Re: Indian Point Unit 2
Docket 50-247

NL-08-101

**SUBJECT: Proposed Changes to Indian Point 2 Technical Specifications
Regarding Diesel Generator Endurance Test Surveillance**

- 1: Analysis of Proposed Technical Specification Changes Regarding Diesel Generator Endurance Test Surveillance
- 2: Markup of Technical Specification Page for Proposed Changes Regarding Diesel Generator Endurance Test Surveillance

FIGURE 44 - TEST 2 3400 AMPERES UPPER PHENOLIC

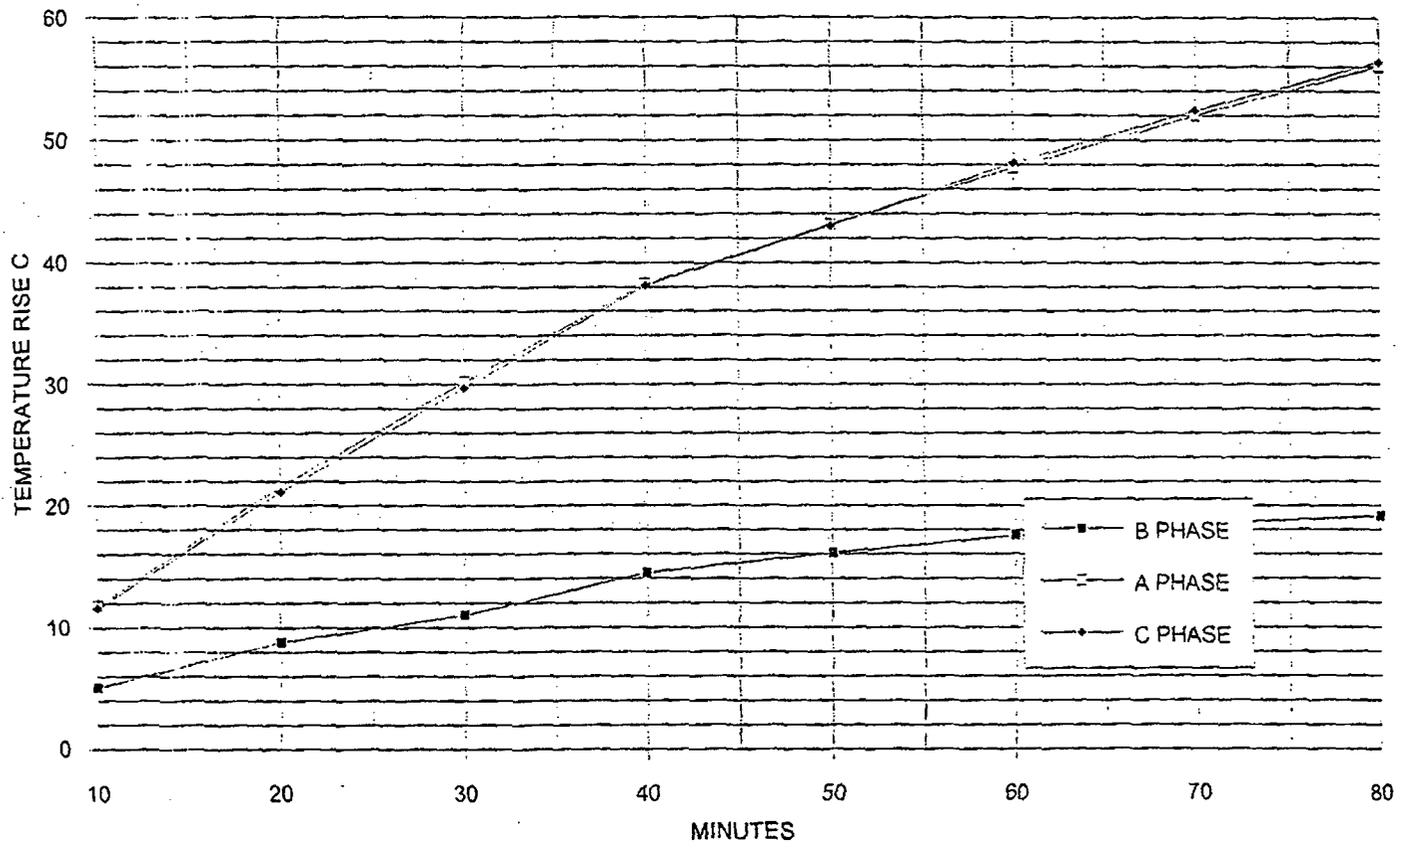
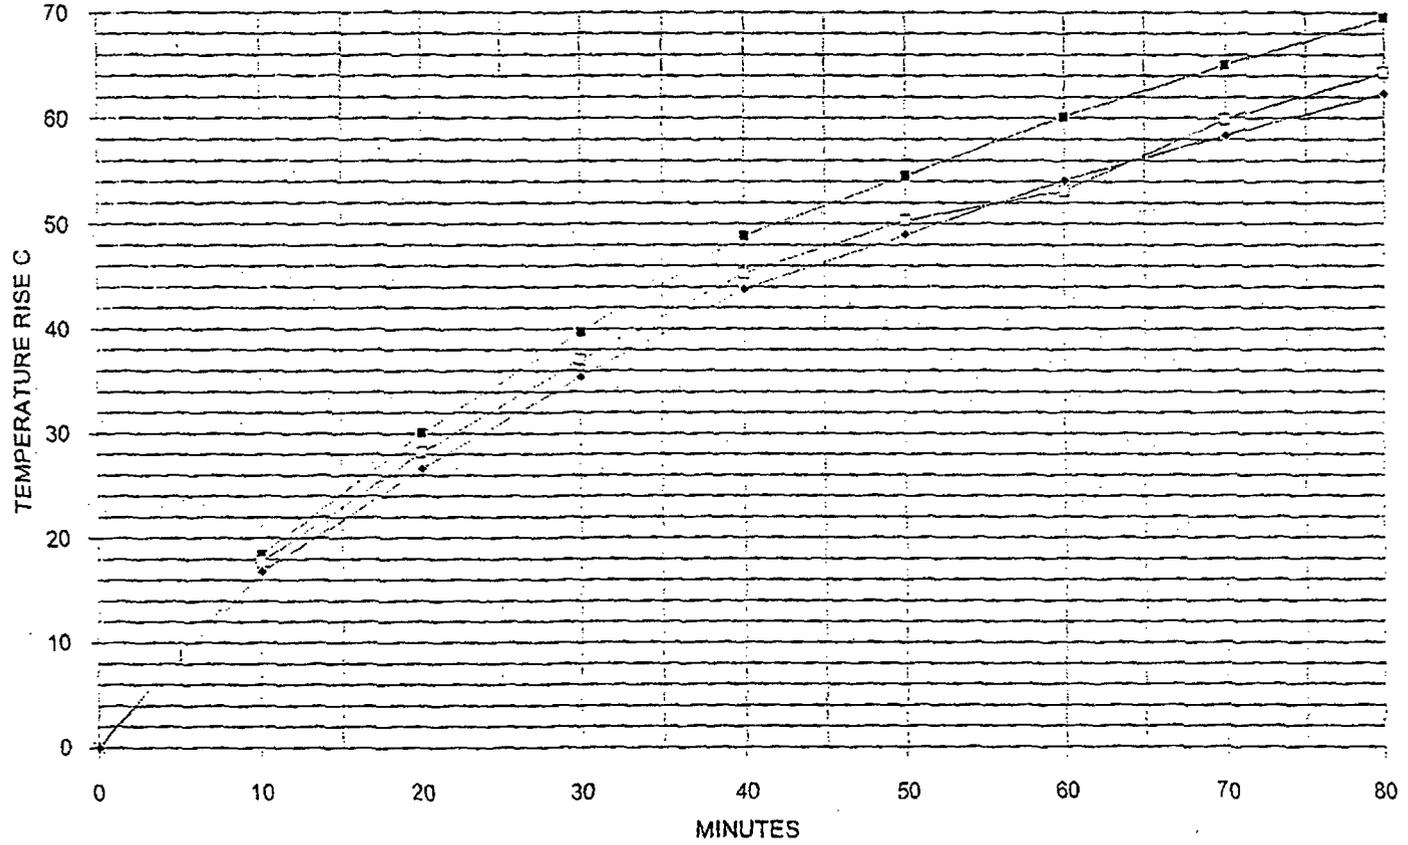
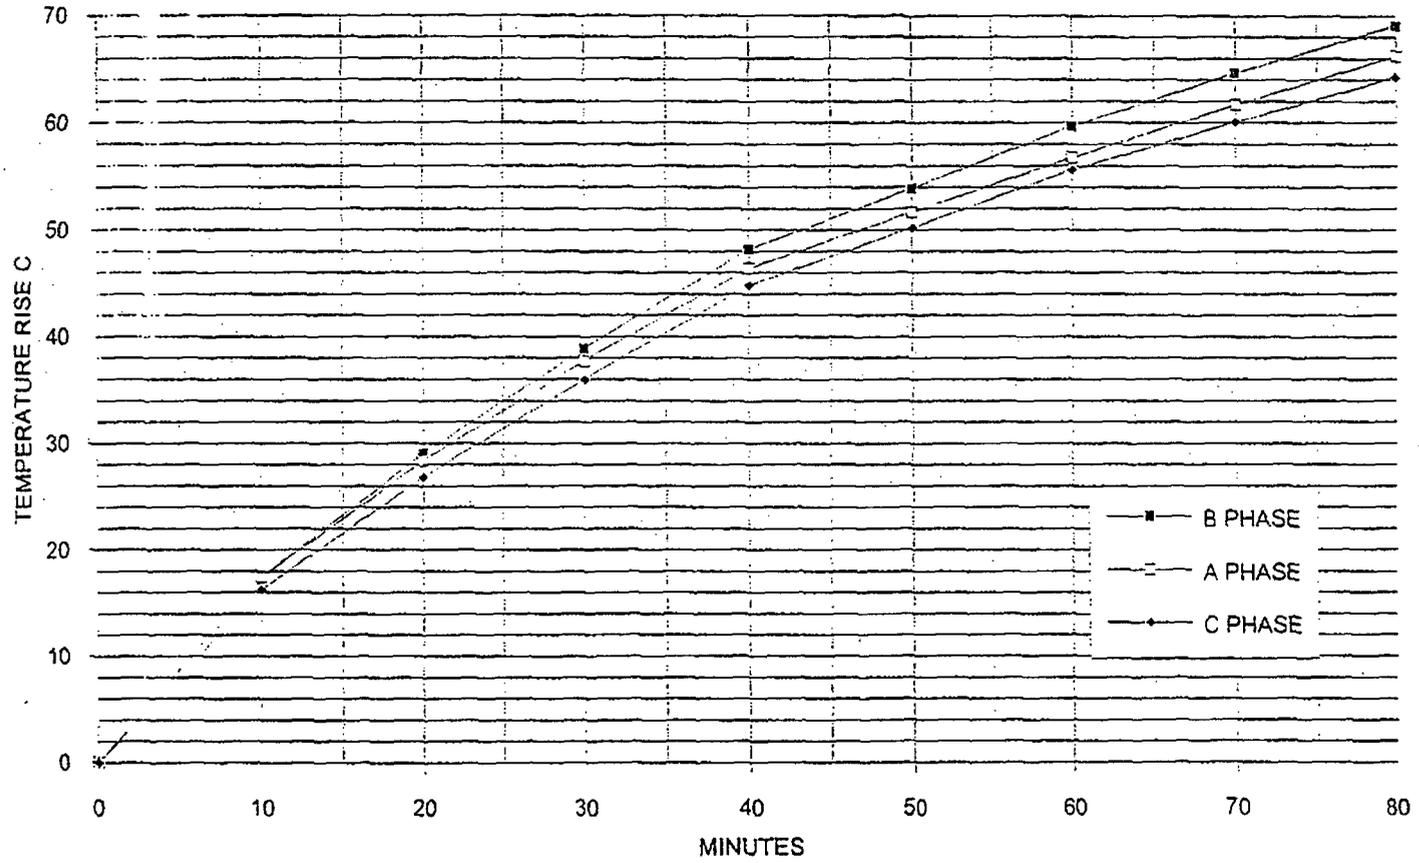
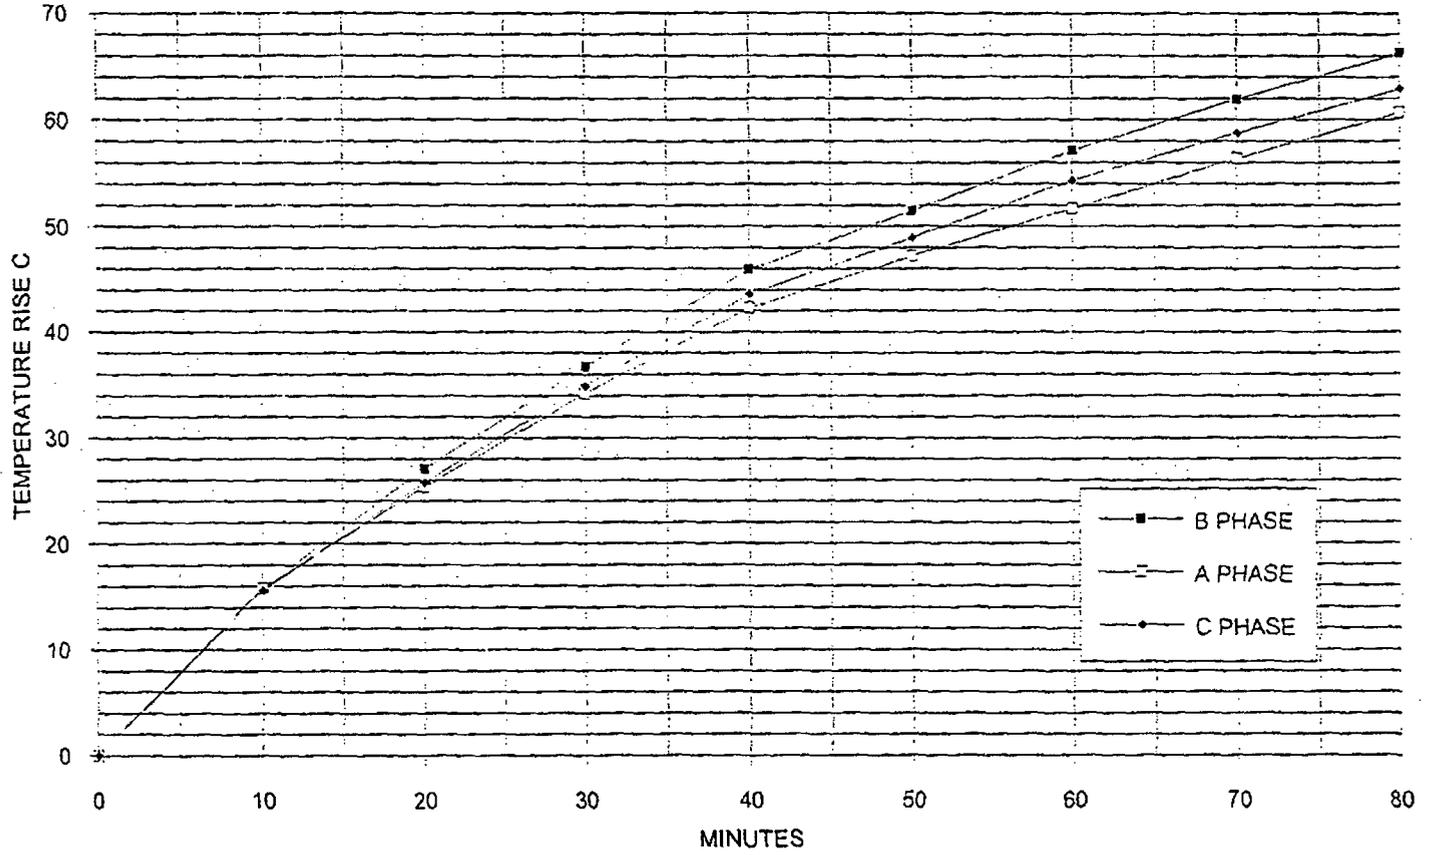
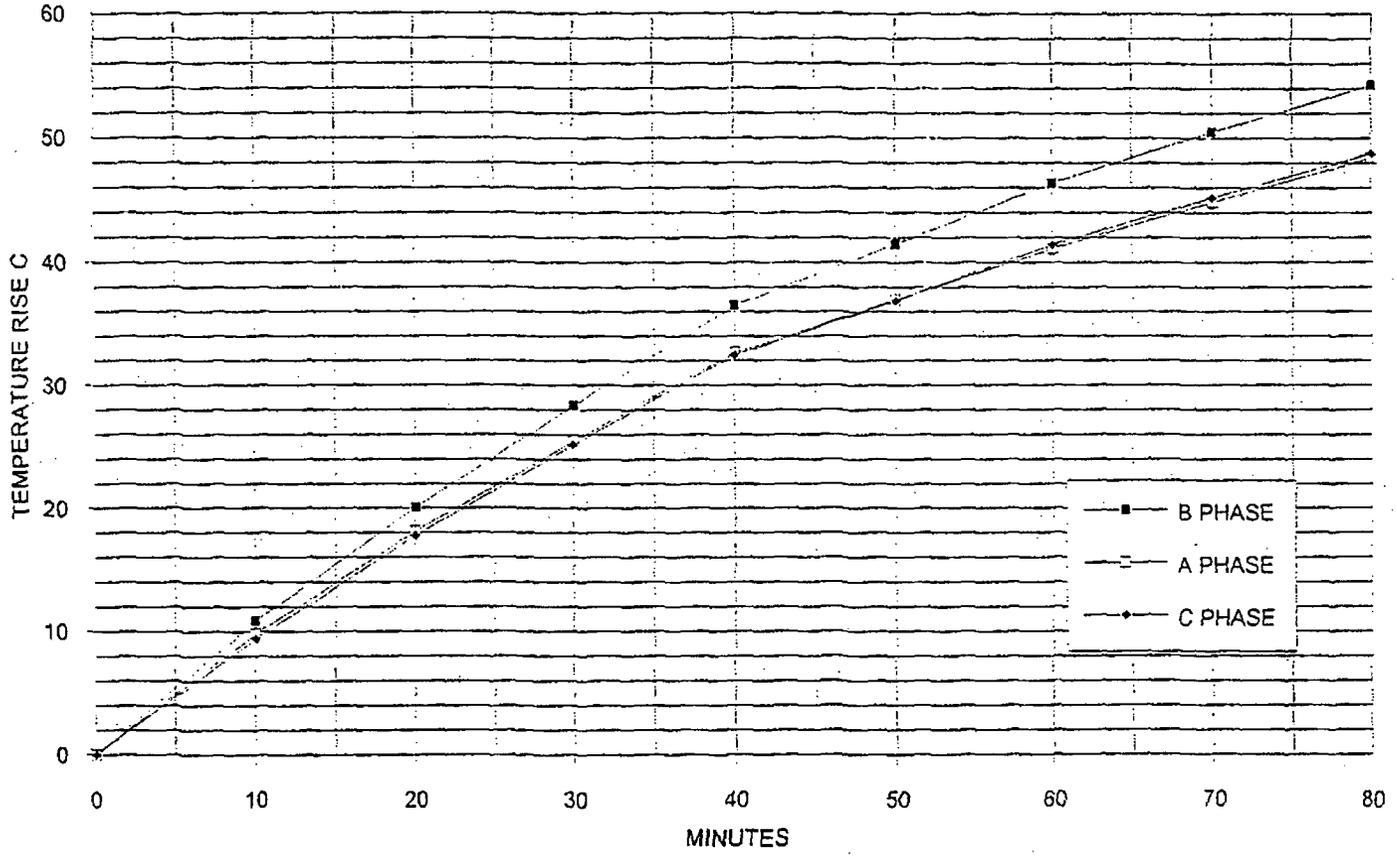
Since normally the EDG breaker is at ambient temperature, (not preloaded), the breaker should be able to operate for a longer time at 2300 kW. The last of the series of tests on the breaker was to energize the breaker from ambient with 3400 amperes until the first component reached its maximum allowable temperature rise. 3400 amperes was chosen to demonstrate margin over the 3300 amperes, which represents 2300 kW (maximum diesel generator output). Figures 43 through 50 show the testing performed during test

cycle 2. The time for the first component to reach its limiting temperature was 80 minutes. For test cycle 3 figures 51 through 58 show the time verses temperature for that test. During that test it took 84 minutes for the breaker phenolic to reach its maximum temperature once 3400 amperes was applied to the cold (no preloaded) breaker.

FIGURE 62 - TEST 3 LOAD DUTY CYCLE BUS DUCT TRANSITION

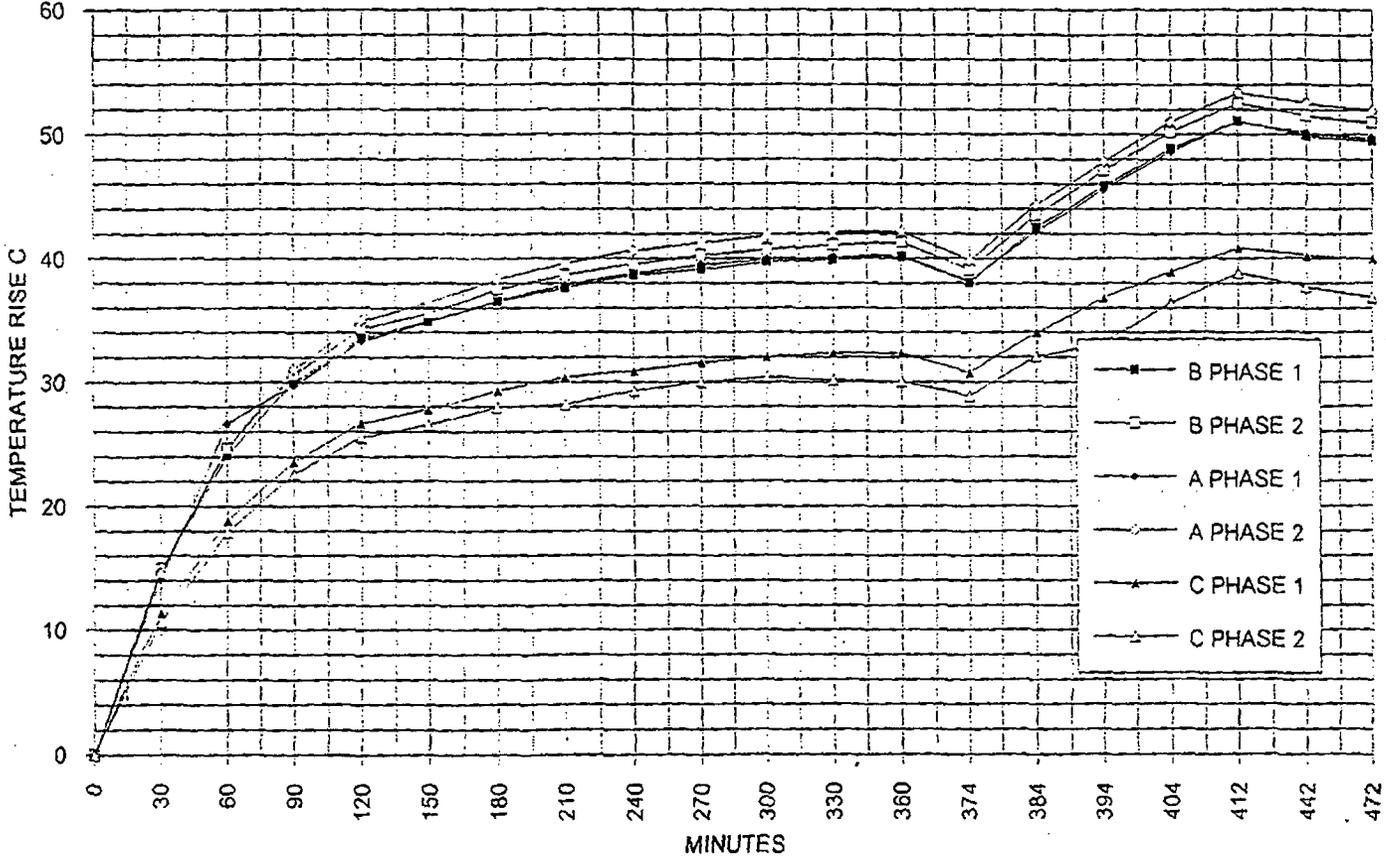
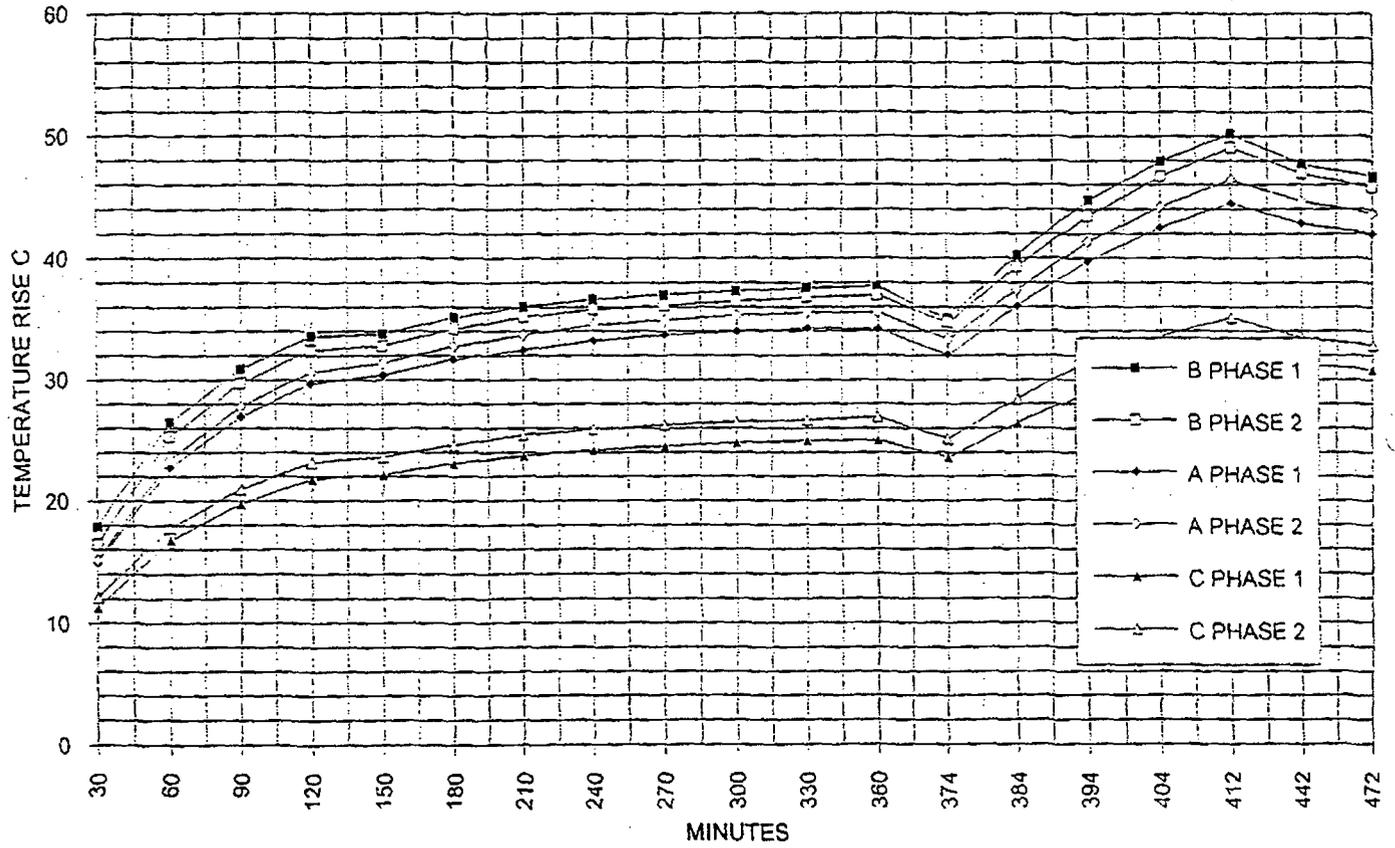
Figures 62 & 63 show the load duty cycle for the transition and bus duct. During the testing, the highest temperatures obtained during the 3300 ampere portion of the test were 54° C for the transition and 50° C for the bus duct. Figures 64 & 65 show the 3400 ampere test from stability, with the transition piece having the highest temperature of 54° C and the bus duct hitting 54° C also.
